Product Change Notification

TVS DIODE PRODUCTS

April, 2012

CDDFN10-0524P Pad Dimensions

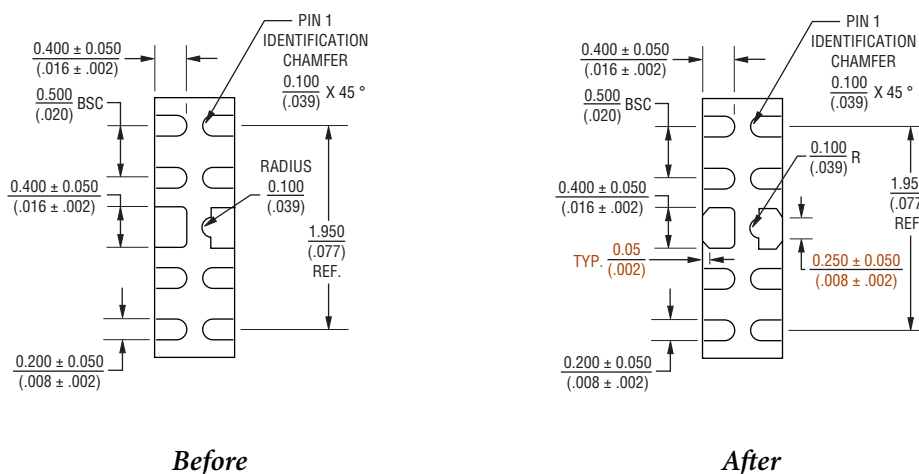
In order to optimize the solder placement of devices mounted on PCB footprints, Bourns is modifying the center ground pad dimensions of the DFN package for our [CDDFN10-0524P](#) TVS diode products.

Deliveries to customers using the new pad layout may occur from October, 2012 onward.
